**REGULAR MEETING  
CONSERVATION COMMISSION  
1 JUNKINS AVENUE  
PORTSMOUTH, NEW HAMPSHIRE  
SCHOOL DEPARTMENT CONFERENCE ROOM**

**September 11, 2024**

TO: Conservation Commission Members  
FROM: Kate Homet, Associate Environmental Planner; Peter Britz,  
Director of Planning and Sustainability  
DATE: September 6, 2024  
SUBJ: September 11, 2024 Conservation Commission Meeting

**Response to Conservation Commission Comments**

**3** Perennial / Ornamental Grass Planting  
1":1'-0" 9.4

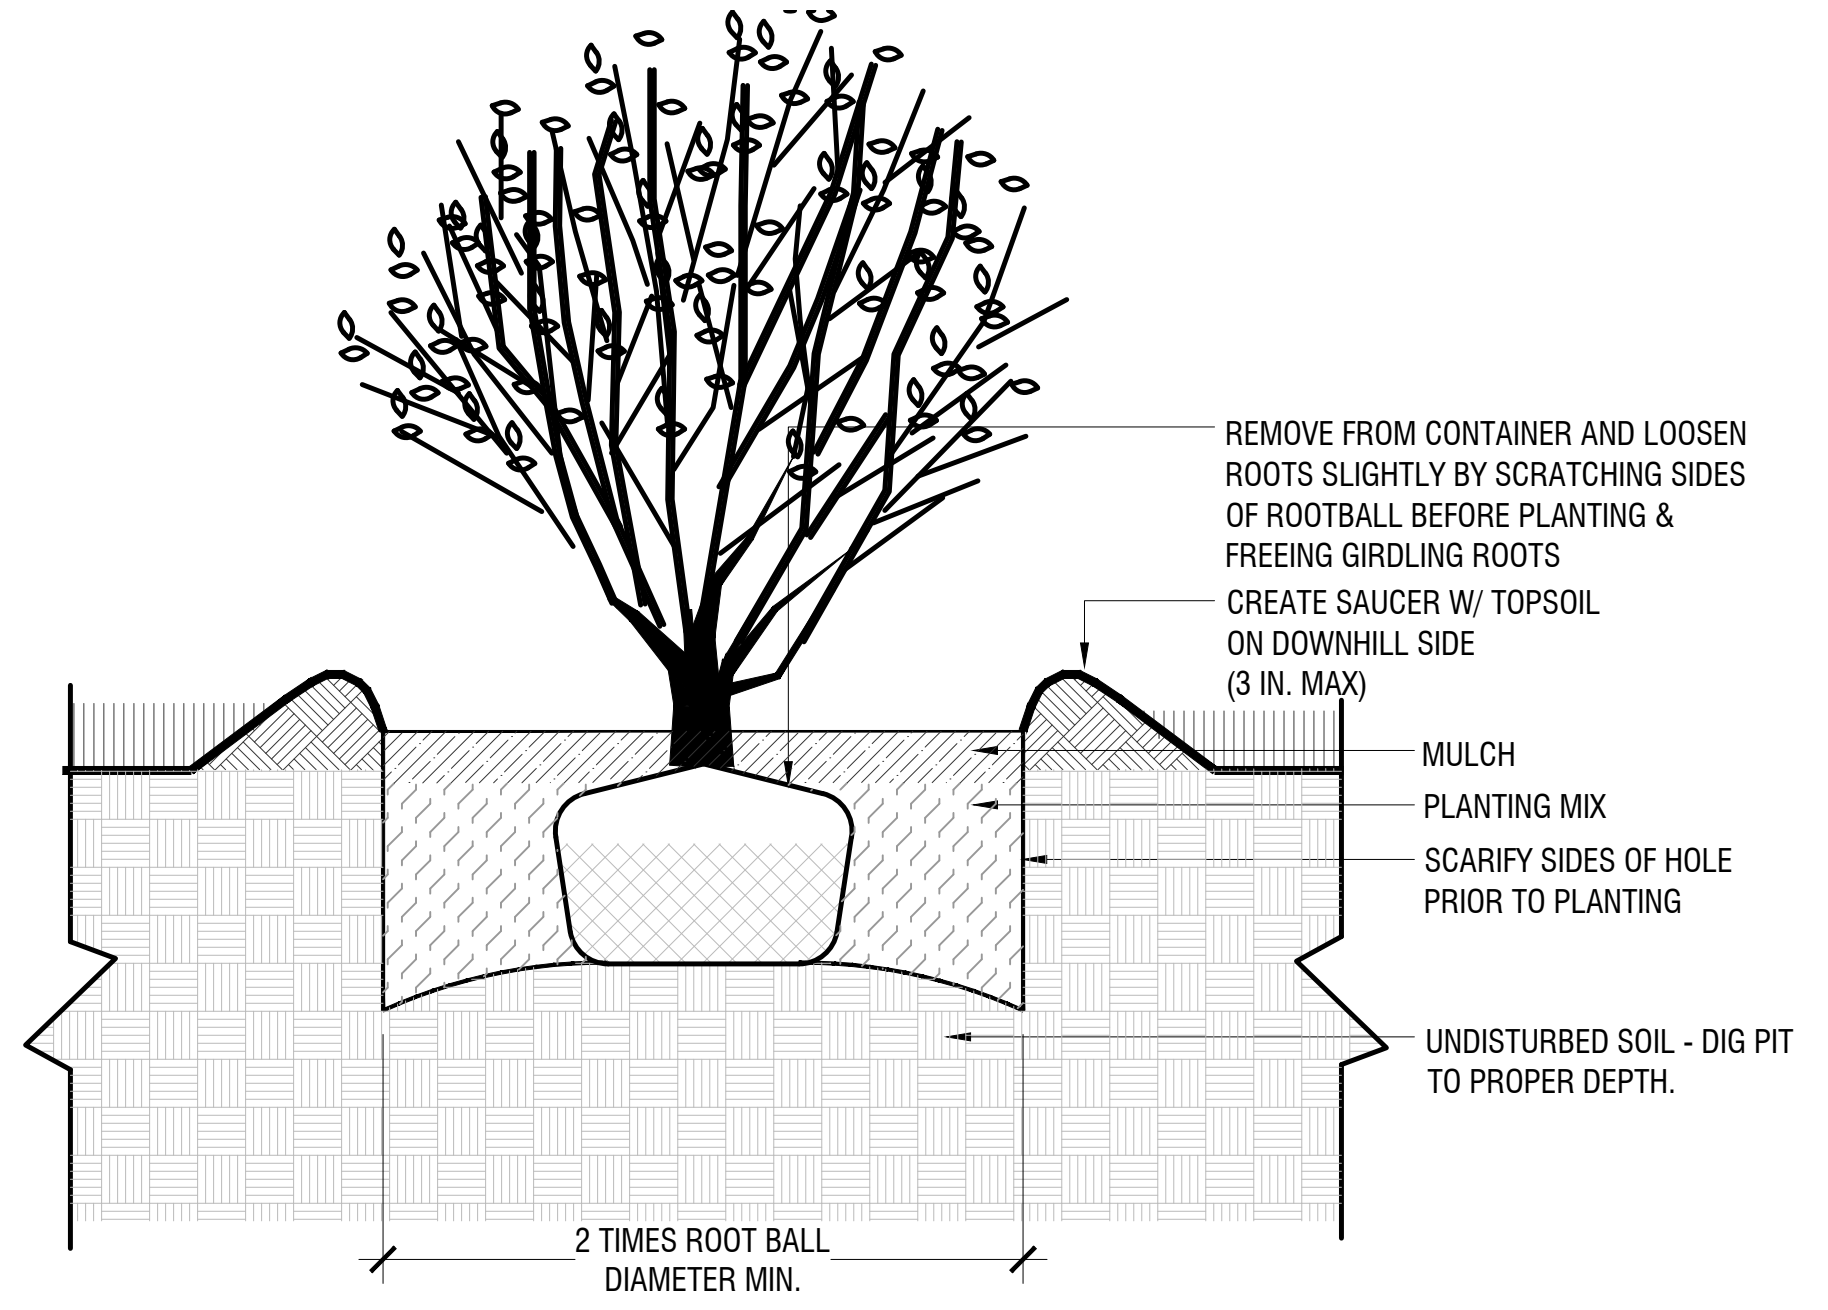
2. *Specify planting and tree sizes, types and locations.*

**Response:** Refer to Sheet L3-00 for full planting schedule and plan.
